CALDECOTE VILLAGE DESIGN GUIDE

Consultation Response April 2019

1. This consultation response has been prepared by Andrew Martin – Planning on behalf of Countryside Properties (UK) Limited, in response to the Caldecote Village Design Guide Consultation Draft, April 2019.

Caldecote Parish Boundary and Bourn Airfield Site Overlay
 Bourn Airfield, South Cambridgeshire

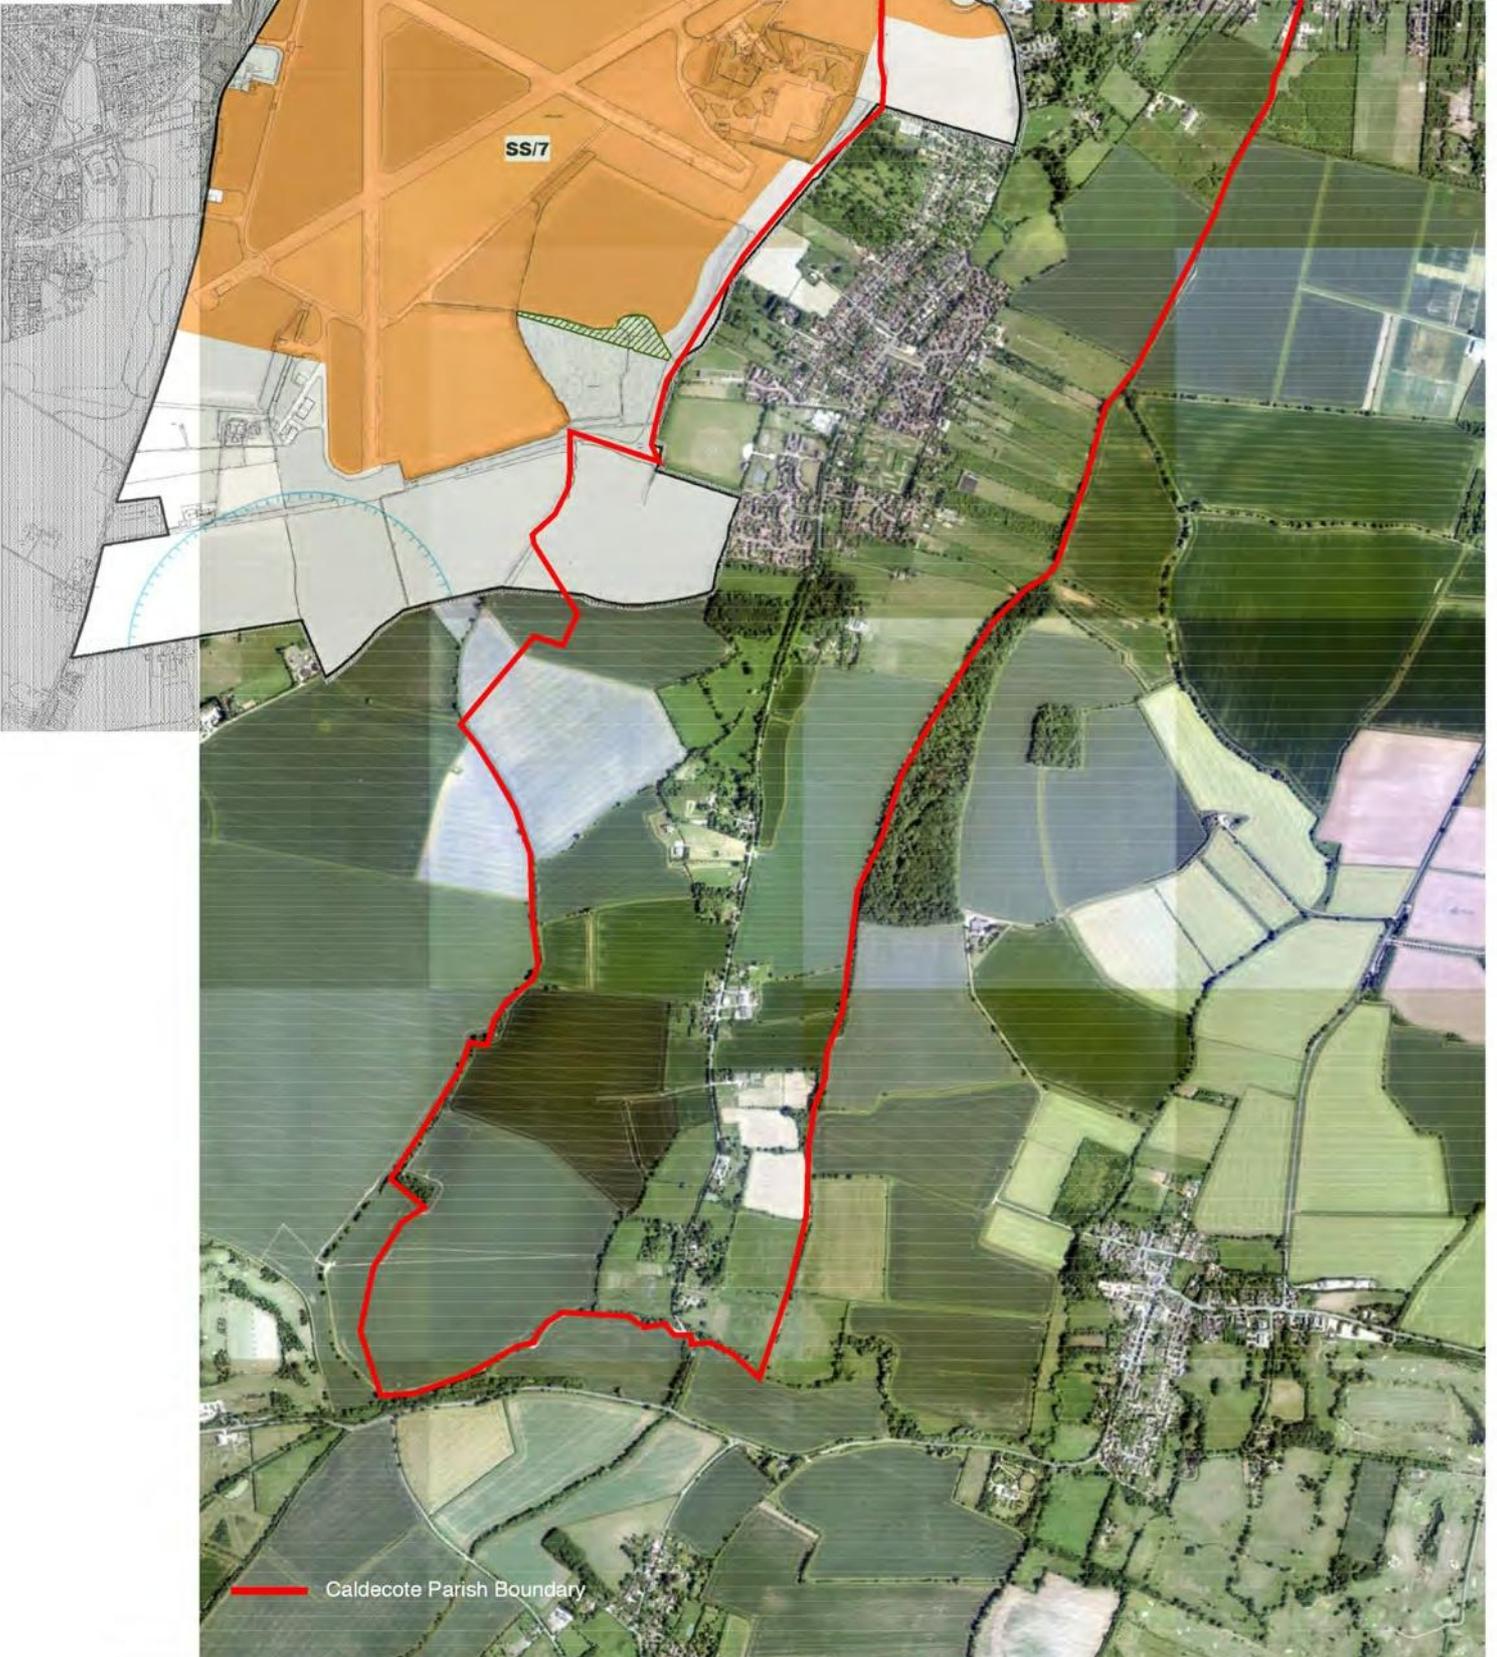
4. The eastern boundary of Bourn Airfield Strategic Site Boundary overlaps with Caldecote Parish boundary. The Caldecote Parish boundary is shown highlighted on an aerial photograph of Caldecote on page 2 of the consultation draft Village Design Guide. The drawing attached to these representations shows the overlap between the Parish boundary and the Bourn Airfield New Village Strategic Site Boundary and Major Development Area (AM-P drawing no 12015_06). Paragraph 9.3 of the Caldecote Village Design Guide states:
